Submit comment on Hybrid Resource Draft Final Proposal

Initiative: Hybrid resources

Figure 1. Output without Downward Deviation Rule

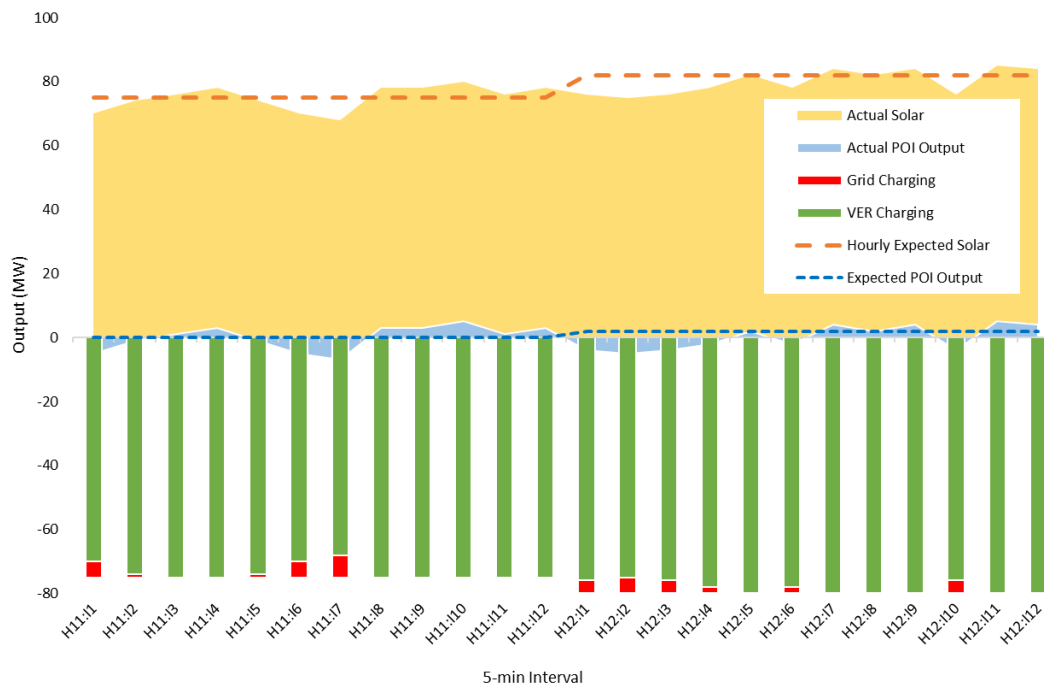
While the proposal to allow co-located storage resources to deviate from dispatch instructions to allow for offsetting VER variation described in the draft final proposal is a step in the right direction, it falls short. CAISO also should allow for downward VER deviations to be offset by reduced co-located resource charging deviations. These deviations are necessary to allow storage resources with Investment Tax Credit (ITC) charging restrictions to choose the co-located configuration without risking inadvertent grid charging that can occur because of VER forecast error between the time storage resource bids must be submitted and energy is produced by the VER in real-time. Figure 1

below illustrates how these forecast error deviations would occur if CAISO does not allow co-located storage resources to deviate from their Dispatch Instructions under the circumstance in which the co-located VER deviates in the downward direction below the level of charging Dispatch Instruction for the co-located storage resource. The inadvertent grid charging that would result either will reduce the ITC benefits of the storage resource or will motivate resource operators to schedule their co-located resources in such a manner that CAISO will not have as much storage capacity available to it or will have more upward uninstructed imbalance energy from VER resources. Neither outcome is desirable.

Figure 2. Output with Downward Deviation Rule

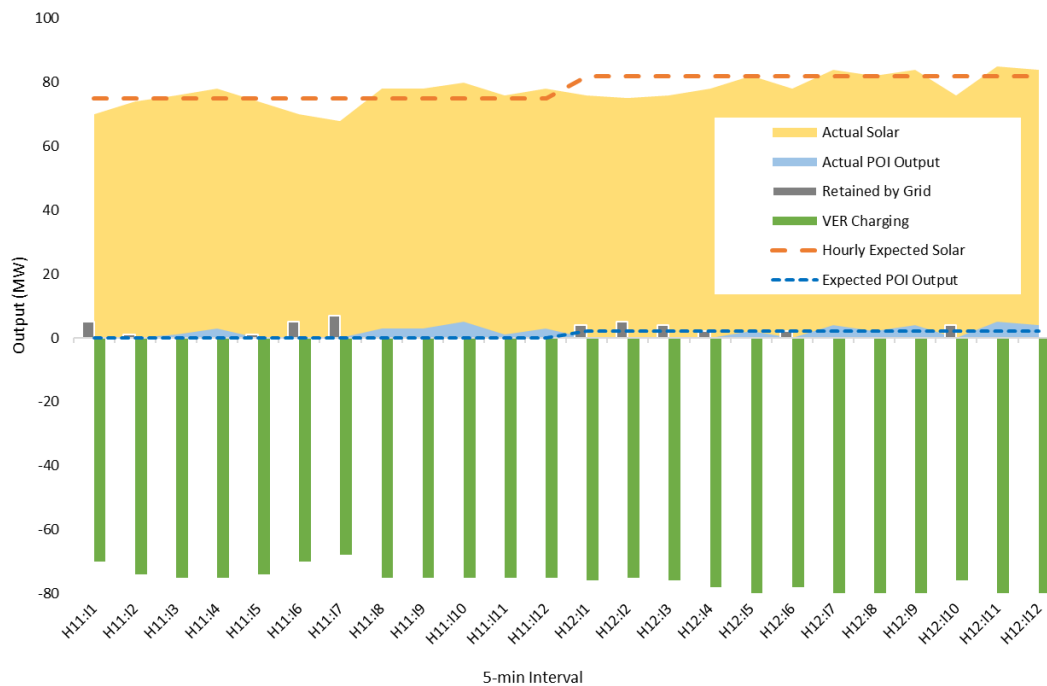
CalCCA urges CAISO to allow the co-located storage resource to deviate from its charging schedule as necessary to avoid inadvertent grid charging due to real-time market VER forecast error. We understand that there may be a concern that this will result in the co-located storage resource having a reduced state of charge for subsequent use. We believe that this concern does not acknowledge the likelihood that either i. some other storage resource that is providing regulation up will provide the energy needed to charge the co-located storage resource whose companion VER is producing less than forecast, or ii. a thermal regulating resource may provide the imbalance energy, resulting in increased GHG emissions. Either result is not desirable. Figure 2 below illustrates that rather than charging from the grid, the unexpected downward deviation in solar output is offset with reduced storage charging in that interval. The result is that for the co-located resource shown, the state of charge is lower than was expected by the 5-minute forecast, however another storage regulation resource likely will have retained its state of charge to offset this deviation. Note that by allowing the storage resource to deviate from its charge schedule when solar output is lower than expected, the actual output at the point of interconnection (POI) for the co-located resource is closer to the expected schedule if downward deviations are allowed, and the amount of VER production and storage resource charging from the co-located resource is the same with or without the downward deviation rule.
